FOXCONN		HON HAI Precision Ind. Co., Ltd.	
Title		CCPBG - R&D Division	
Size		Document Number	
Custom		M9A0 MP	
Date:		Wednesday, October 28, 2009	Sheet 5 of 73
		Rev 1.1

FOXCONN		HON HAI Precision Ind. Co., Ltd.	
Title PCH (PCI-E, SMBUS, CLK)		CCPBG - R&D Division	
Size	Document Number	Rev	
Custom	M9A0 MP	1.1	
Date:	Friday, October 23, 2009	Sheet	10 of 73

FOXCONN		HON HAI Precision Ind. Co., Ltd.	
		CCPBG - R&D Division	
Title	VGA (PCI EXPRESS) 1 OF 9		
Size	Document Number	Rev	
Custom	M9A0 MP	1.1	
Date:	Thursday, November 19, 2009	Sheet	21 of 73

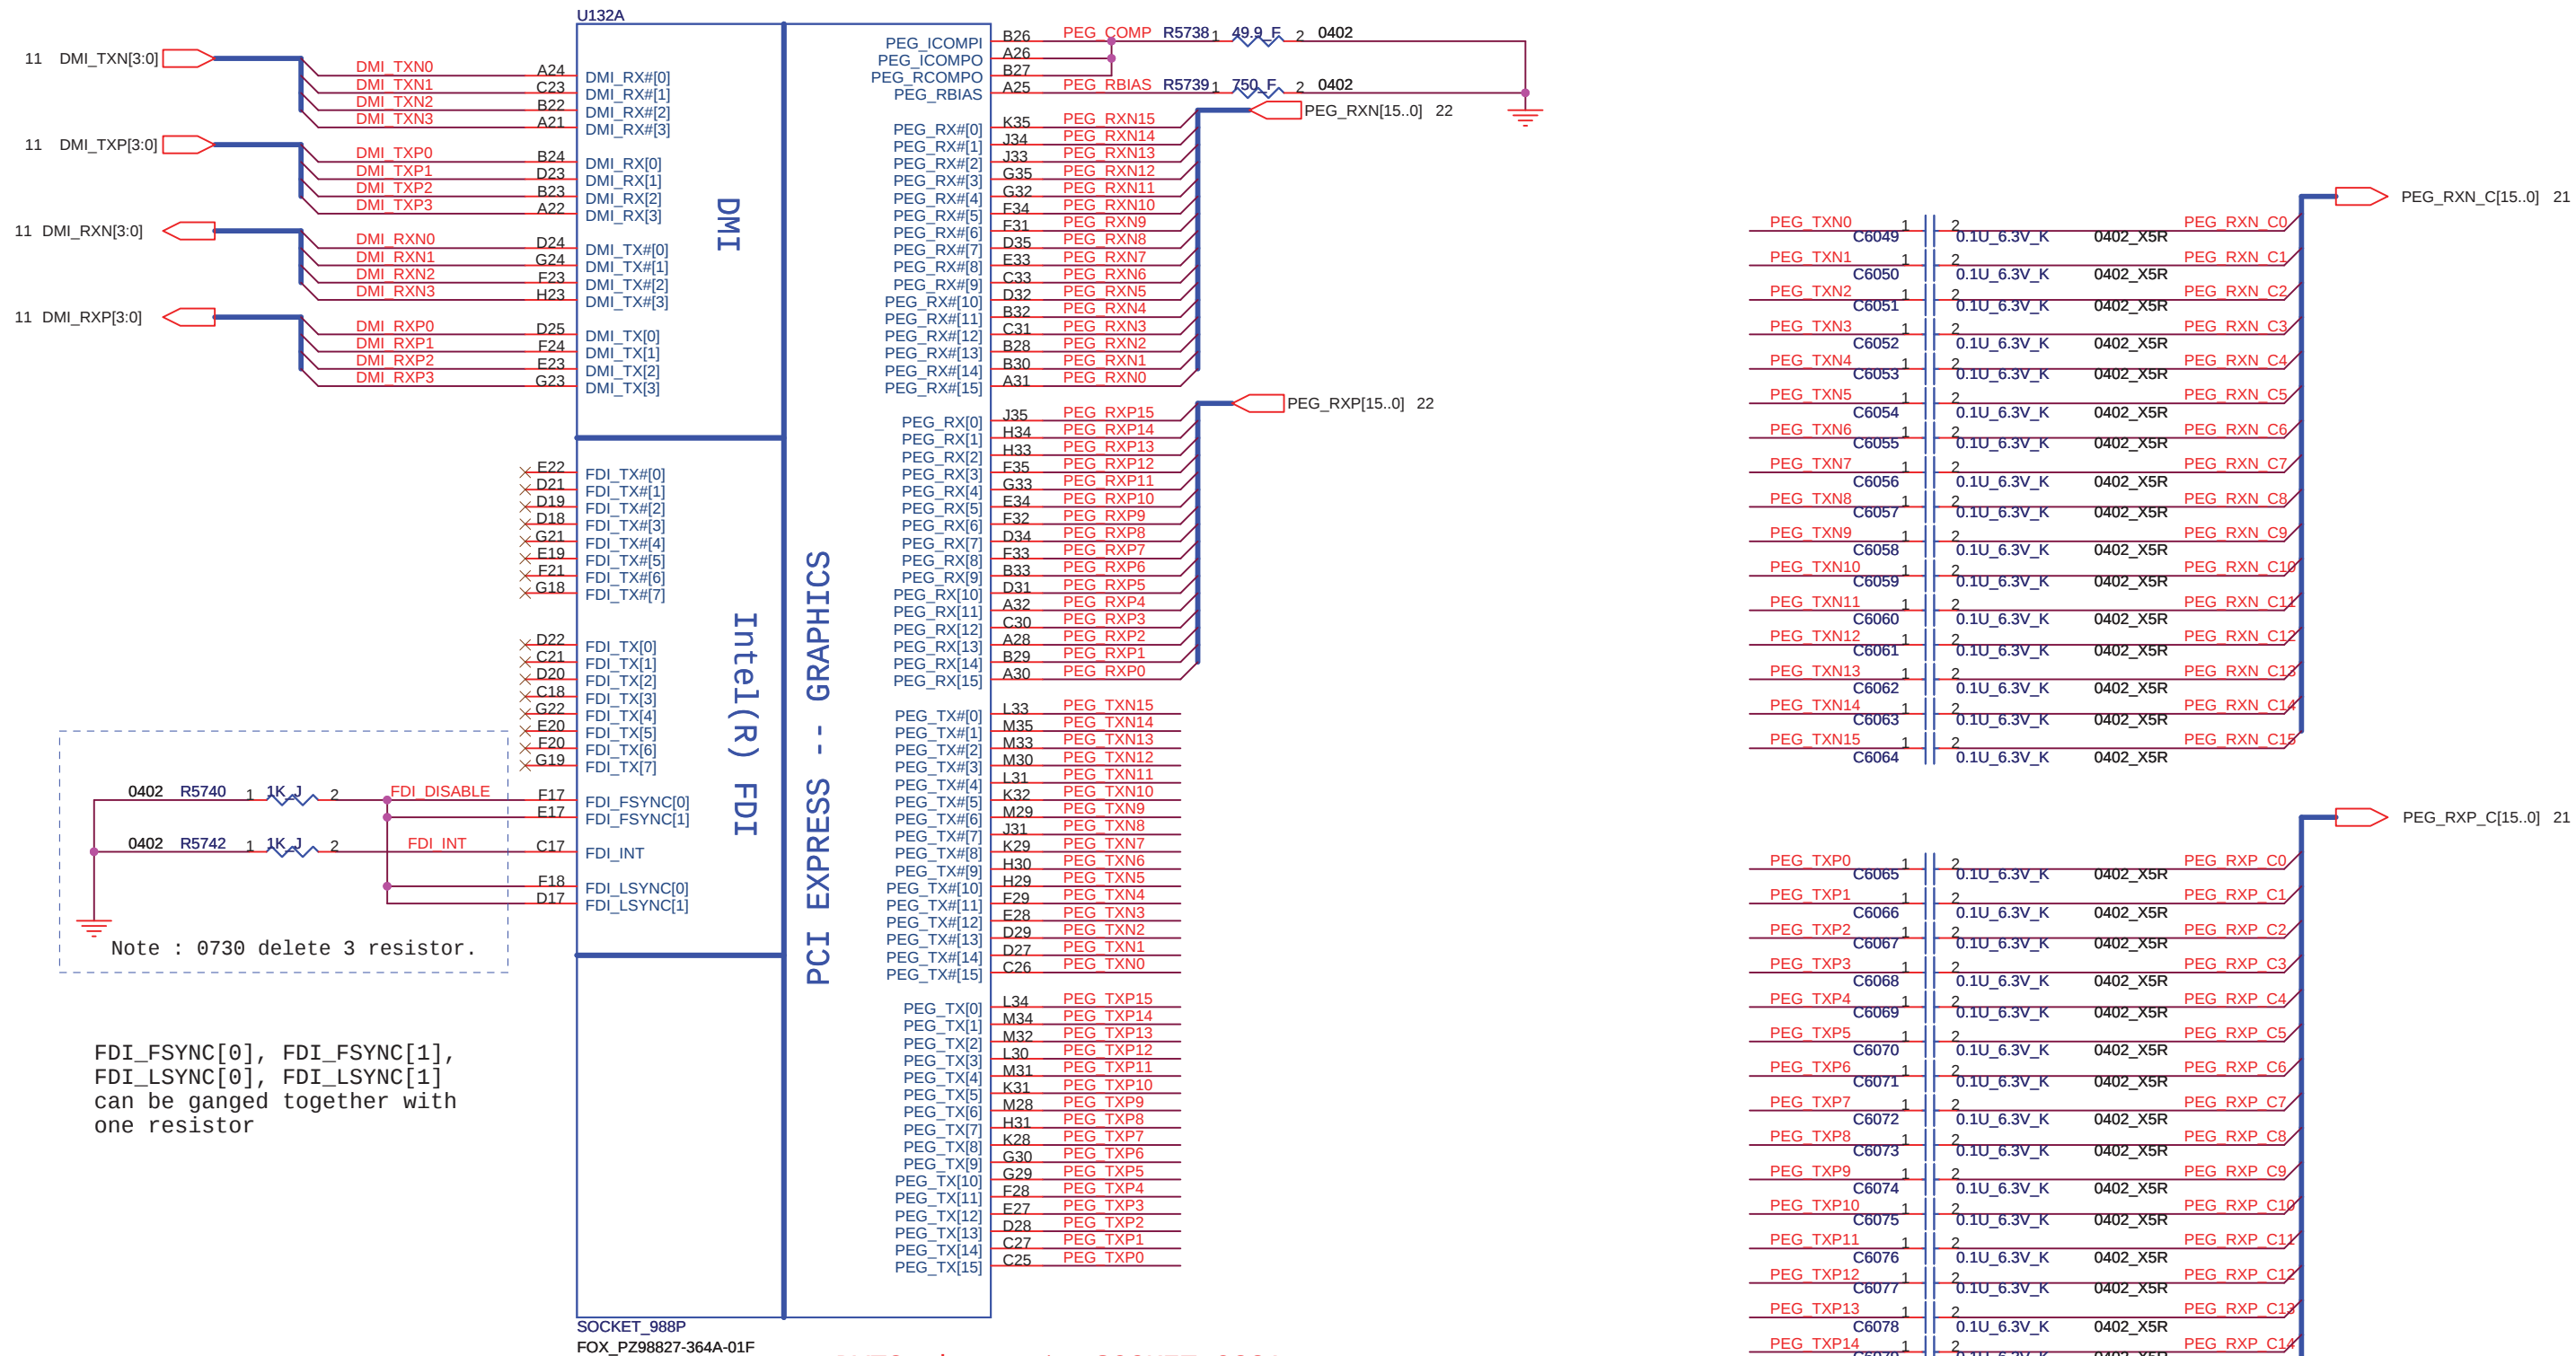
DVT2 change to SOCKET_988A

For Disable Arrandale Graphic
In addition, FDI_RXN[7:0] and FDI_RXP[7:0] can be left floating on the PCH.
FDI_TX[7:0] and FDI_TX#[7:0] can be left floating on the Arrandale. The FDI_FSYNC[0], FDI_FSYNC[1], FDI_LSYNC[0], FDI_LSYNC[1], and FDI_INT signals on the Arrandale side should be tied to GND (through 1-kΩ ±5% resistors).

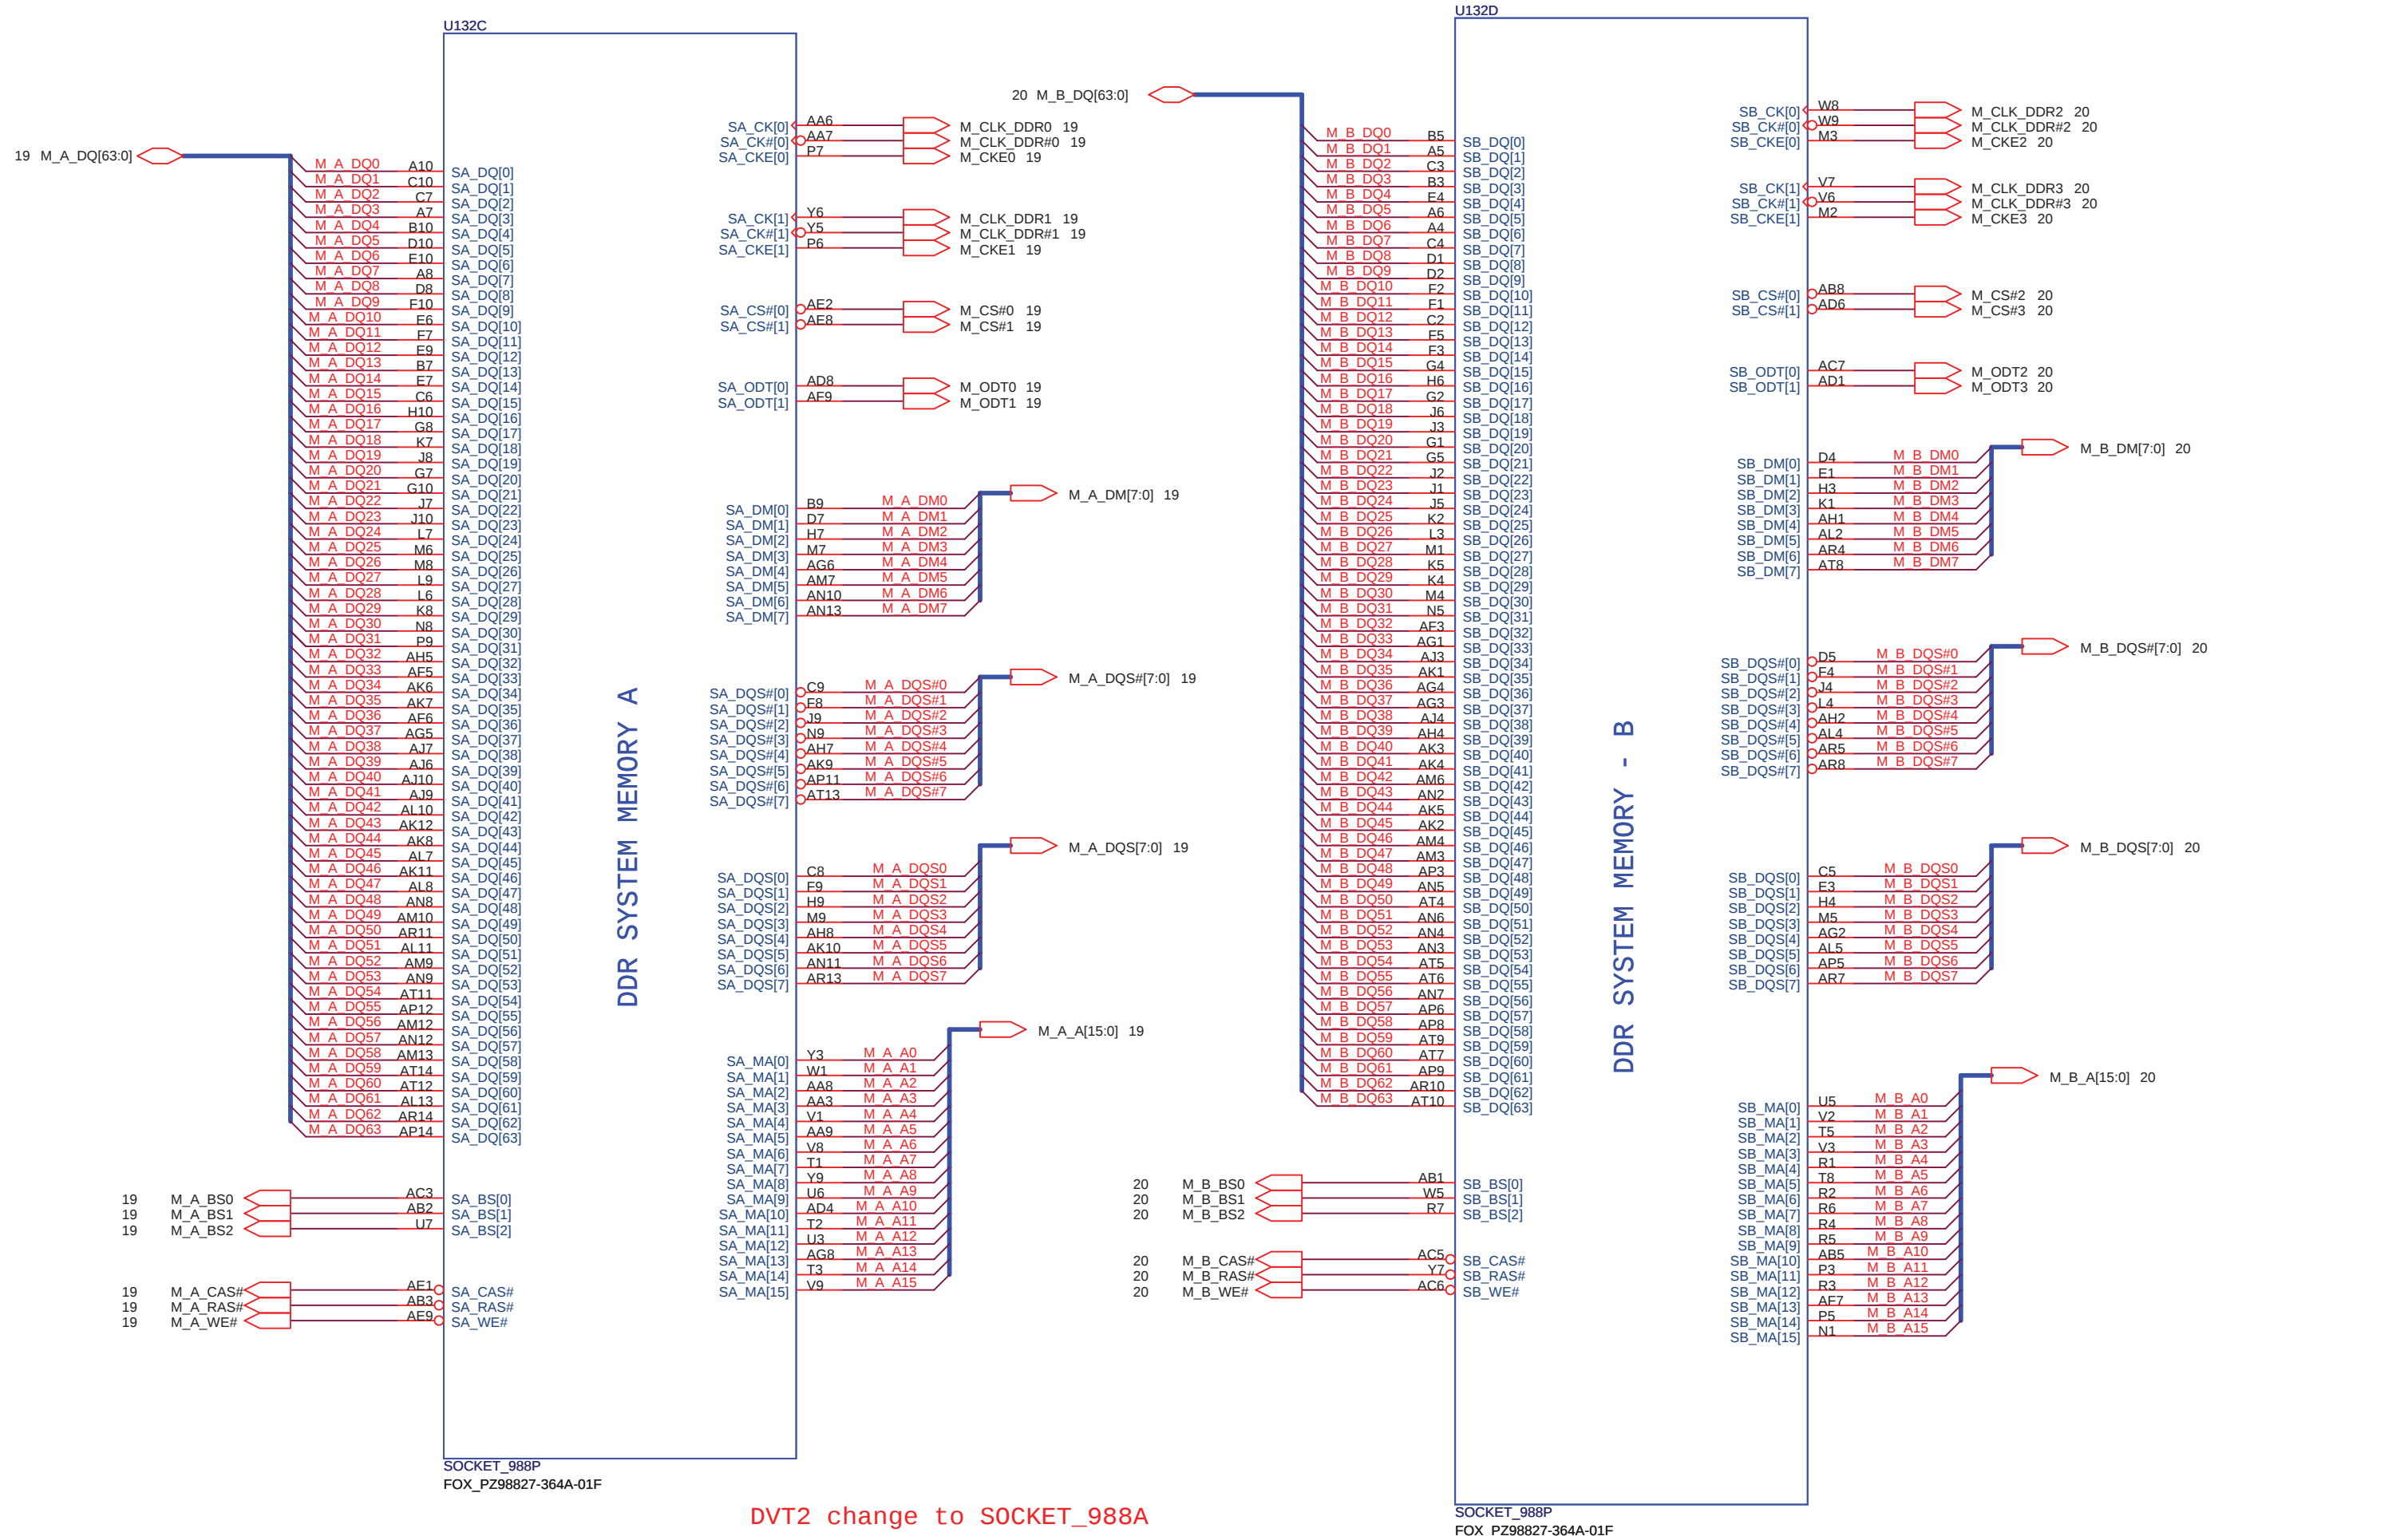
```
2009.10.19
Change RP81 TO NC
Change RP82 TO mount
```

Delete R5785 0ohm resistor for voltage drop problem

Delete R5786 for PVT

2611030 PCI Express Interface May Not Meet PCI Express 2.0 Jitter Specifications

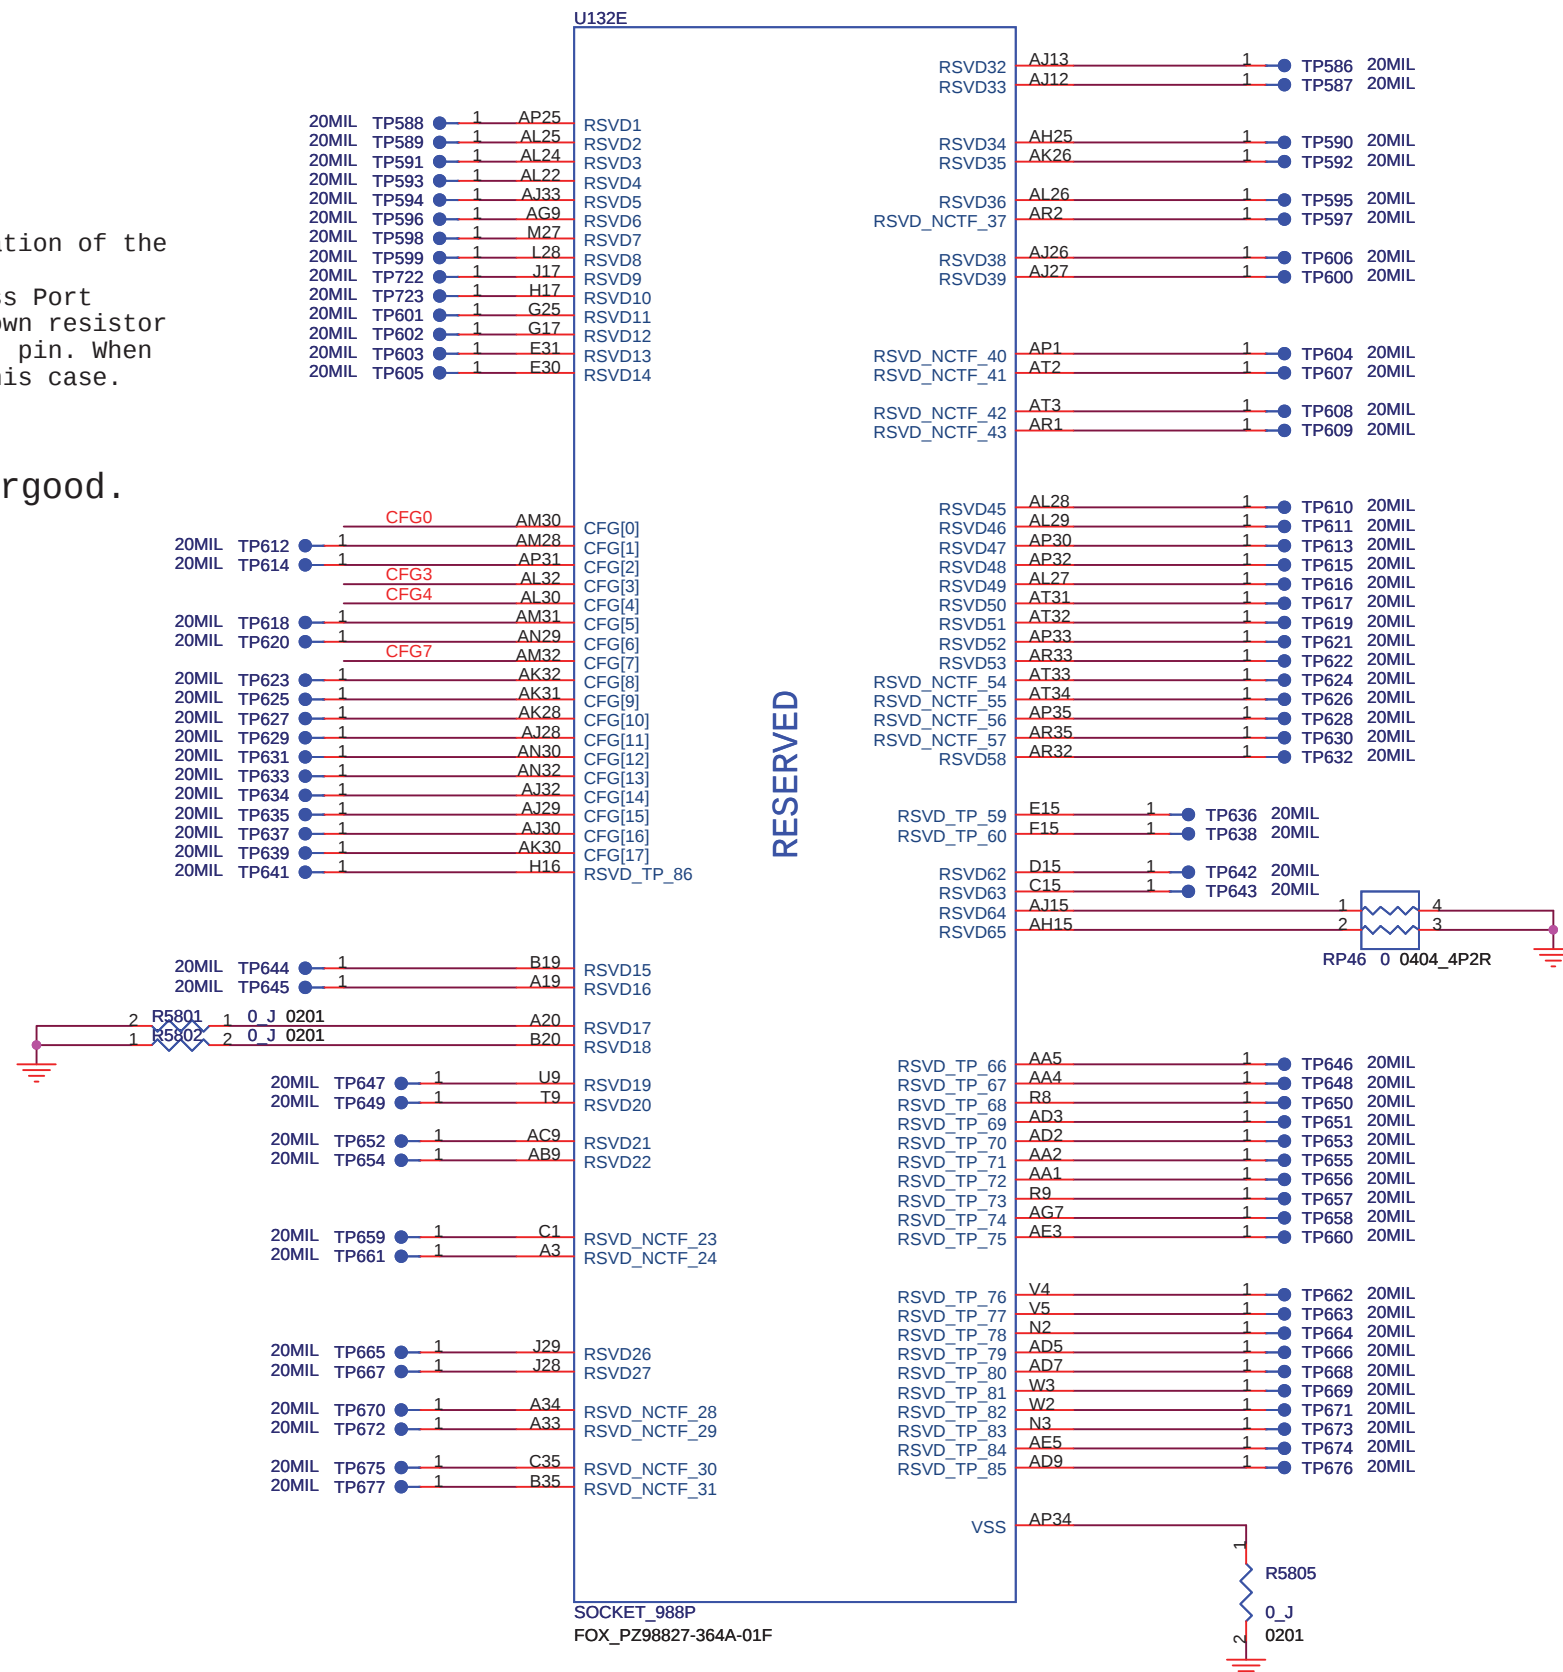
Intel has determined that the workaround (3.01K pull down to Vss on signal CFG[7]) is not robust. Intel recommends not implementing this workaround at this time (CFG[7] should not be pulled down). Intel recommends not to test for PCI-E Express 2.0 Jitter specification compliance for the affected steppings.

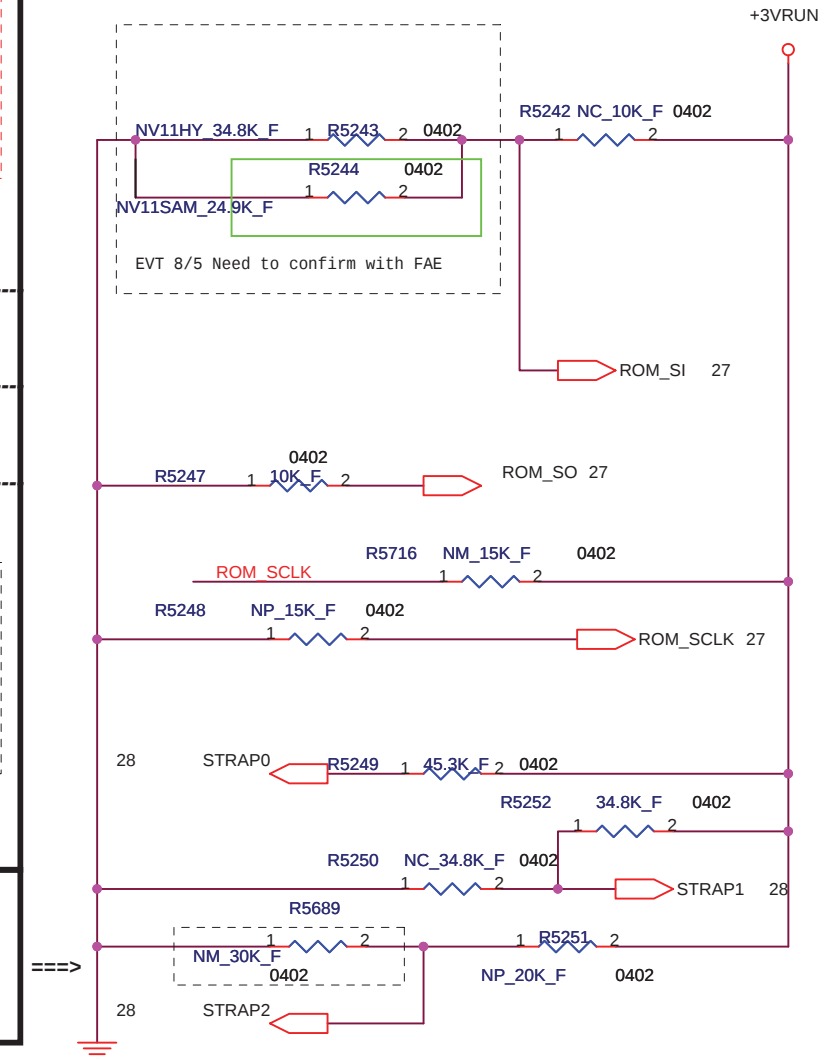
2009/9/10
N11P-LP1+SANSUNG(H2) SKU and N11M-GE1 +SANSUANG(M2 SKU)need change BOM
R5244 change from 1R-0004532-F200(45.3K) to 1R-0002492-F200(24.9K) for nVIDIA FAE suggest
